651S-1
GENERAL PURPOSE HF RECEIVER

PUB NO.	NOTE	DATE	SUBJECT
IB 1-72 ✓		03/01/72	Subassembly Interchangeability
SB 1		10/01/72	Reduction of 450-kHz Leakage From Synthesizer Reference Board All
SB 2		06/06/73	Reduction of Noise Level
SB 3		07/15/73	Add Keep-Alive Frequency Memory Function
SB 4		07/15/73	Extend Comma and Decimal Lamp Life in Frequency Display
SB A ✓		11/01/73	Change DCFE Filter Switching Diode
SB 5	1	12/15/74	Minimize TCU Circuit Card Response to Data Link Noise and Failure
SB 6	2	03/01/75	Reduce Intermodulation Level
SB 7		02/07/75	Reduce Internal Spurious Signals
SB 8		12/27/74	Allow Remote Control Operation With RS-232C Serial Control Interface Card A9
SB 9 ✓		02/15/75	Increase Life of Display Tubes
SB 10 ✓	2	12/31/75 Revised 08/02/76, 04/01/77	Replacing Display Tubes With LED Plug-in Assemblies
SB 11		Not issued	
SB B ✓		11/15/74	KAV
SB C ✓		01/15/78	Supply KAV Power to DCFE
SB 12 ✓		05/01/78 Revised 07/01/78	Replacing Nonprocurable Integrated Circuits

SERVICE BULLETIN A

SUBJECT: Change DCFE Filter Switching Diode

651S-1 Sideboard, Bottom View, Connector Locations
Figure 2

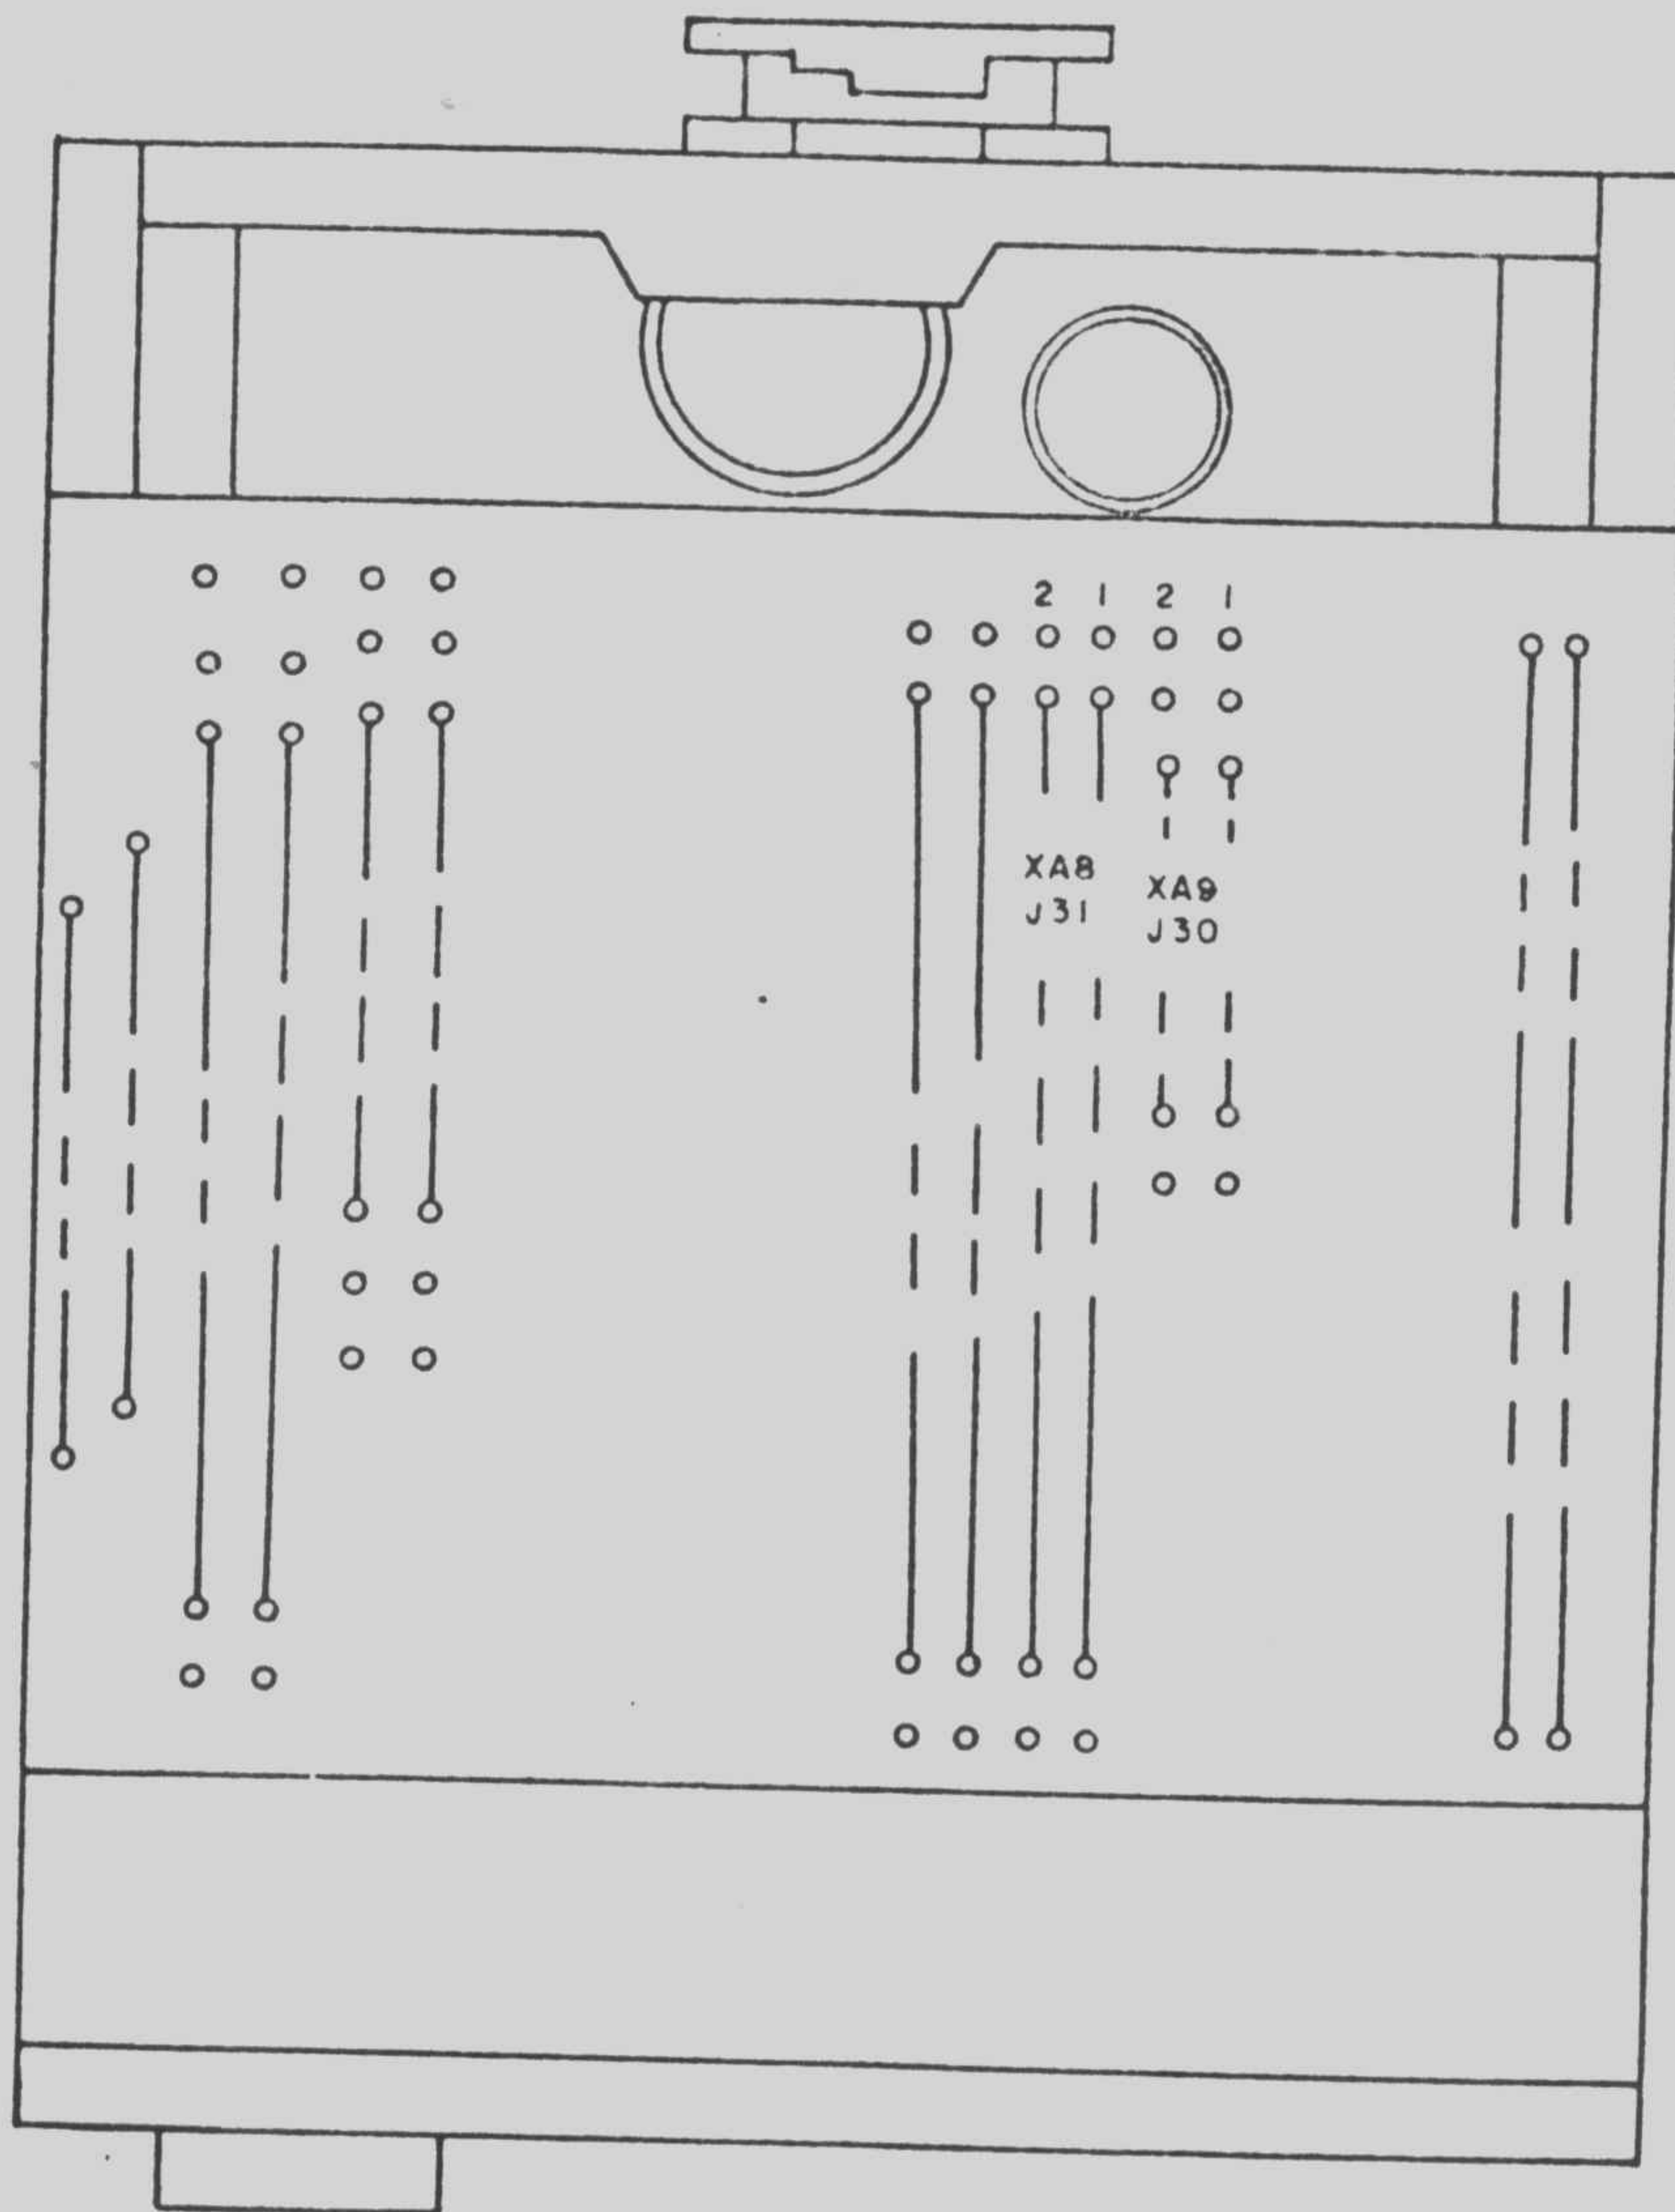
- B. Remove the DC FE circuit card A8, CPN 624-5744-001, from the receiver.
- C. Disconnect +5-volt power by removing contact P1-27 from the blue line connector on the card. Refer to figure 1.
- D. On the back of the card, connect a #26 insulated bus wire (422-4008-000) from the vacated hole at P1-27 to spare contact P1-48.
- E. Mark "KAV OPERATION" near the part number on the card.
- F. On the receiver sideboard, connect a #26 insulated bus wire (422-4008-000) from XA8-48 to XA9-22 to provide keep-alive power to A8. Refer to figure 2.
- G. Reinstall DC FE card in receiver.
